# DEVELOPMENT REVIEW COMMITTEE (DRC) COMMENT REPORT

**PROJECT NAME:** The Mansions at Riverland

**CASE NUMBER:** UDP-S23061

**REQUEST:** Site Plan Level II Review: 11-Unit Townhouse  
Development

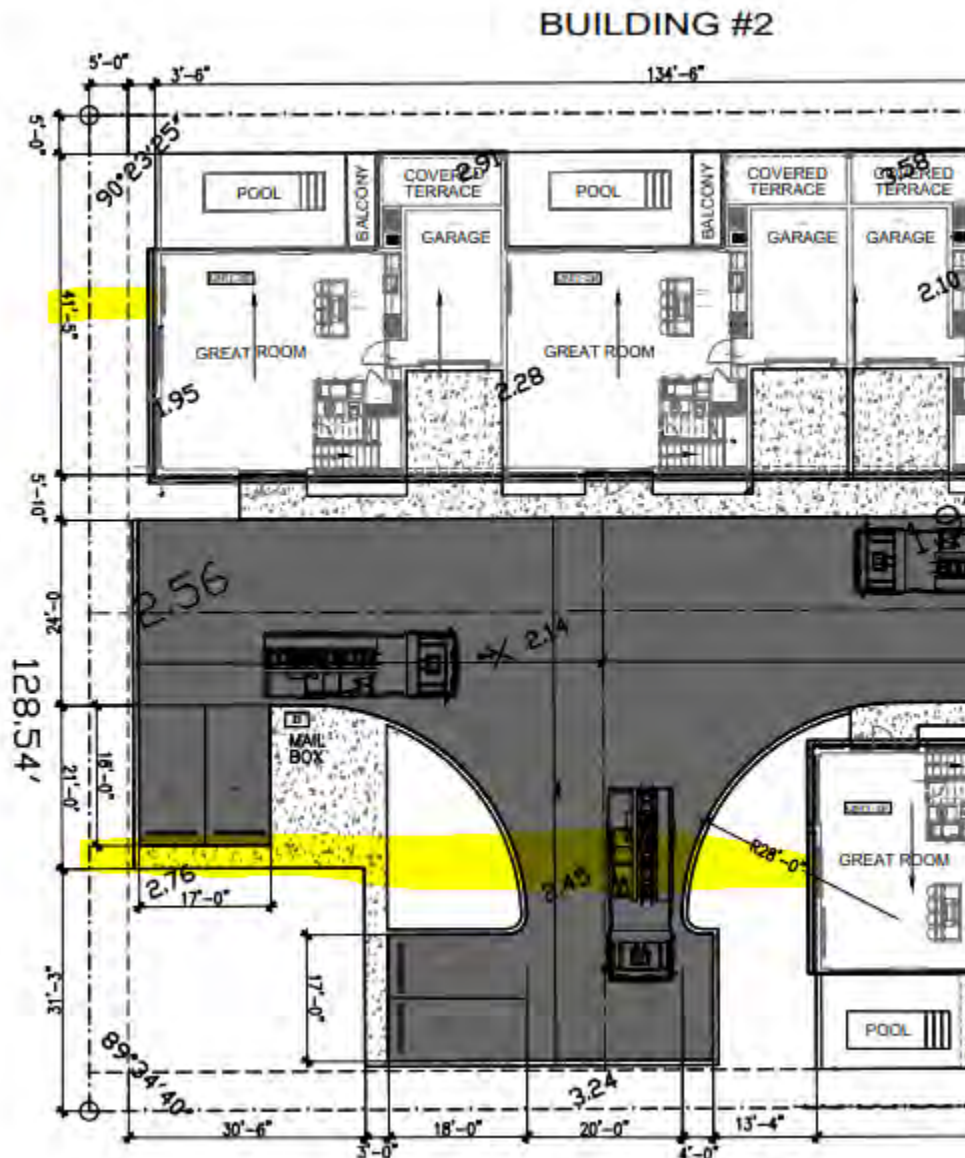
- i. Provide rear yard setback measurements. Missing measurements are identified below.
